EAST PARK ENERGY

EN010141

**Applicant's Response to Deadline 3
Submissions – Host Authorities, Statutory
Environmental Bodies and Statutory
Undertakers**

Document Reference: EN010141/DR/8.39

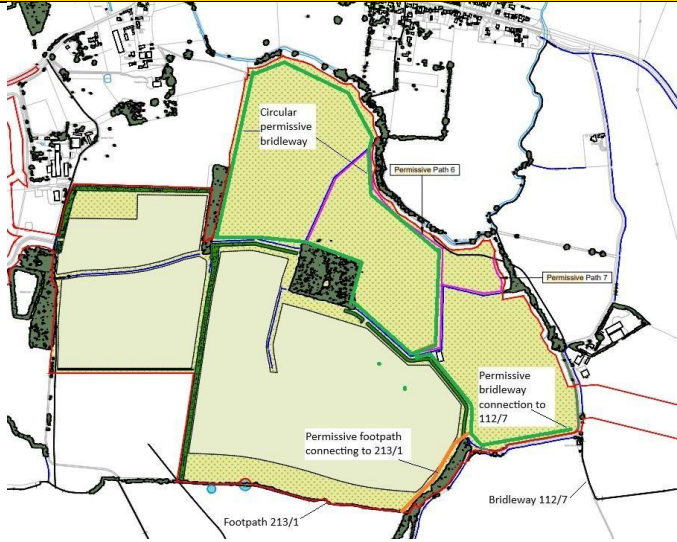
CCC-D3-02	2.3.10	The Council seeks the Illustrative Environmental Masterplan [APP-121] be updated to remove this drafting error. Although it is an illustrative masterplan, it must be accurate and avoid any errors being carried forward into production of detailed landscape drawings etc. The orange circle on drawing below indicates location of where some of the triangle of existing woodland is being	The Applicant is not proposing removal of any of the woodland habitat identified within the orange circle indicated by CCC. The existing vegetation shown is derived from the BlueSky National Tree Map which shows canopy extent, hence the gap in the vegetation which aligns with aerial imagery visible from other sources. The plan is illustrative only with the host authorities

Our Ref.	Ref.	CCC Comments	Applicant Response
		lost to another habitat (although it is unclear what this habitat will be) on Sheet 10 of Illustrative Environmental Masterplan [APP-121] 	having approval of the final landscape proposals through Requirements 3 and 4 of the draft DCO [REP3-009]. The Applicant has amended Figure 4 in Appendix A of the oLEMP [as updated alongside this submission] to update the graphics in this location.
CCC-D3-03	2.3.13	The Council does not agree with the applicant's approach for surveying trees for bats. The implementation of a sensitive lighting scheme is not considered adequate measures to avoid more survey work because at this stage, the location and light spill from these luminaires during construction is unknown, and some bat species are very light sensitive and require dark corridors (i.e. sensitive lighting will be ineffective, instead, no lighting is required). We would expect trees to have been surveyed, unless it can be demonstrated that dark corridors of sufficient size (e.g. 10m suggested by Natural England) adjacent to trees with roosting potential and connections to foraging / commuting routes. Spring is the start of the active bat survey period and therefore, provided a good opportunity to complete the necessary survey work during the progression of the Examination.	The Applicant notes that Natural England expressed in their response to the ExA First Written Questions [REP3-083] that they '<i>do not disagree with the conclusions on [sic] their environmental statement</i>'. Nonetheless, additional measures have been discussed with CCC and included in the outline Construction Environmental Management Plan (oCEMP) [as updated alongside this submission], including: • Commitment to providing light spill plans and agreeing a lighting strategy with the host authorities • Pre-construction survey of trees • Ecological Clerk of Works (EcoCoW) to assess boundary trees and advise on appropriate mitigations or further survey
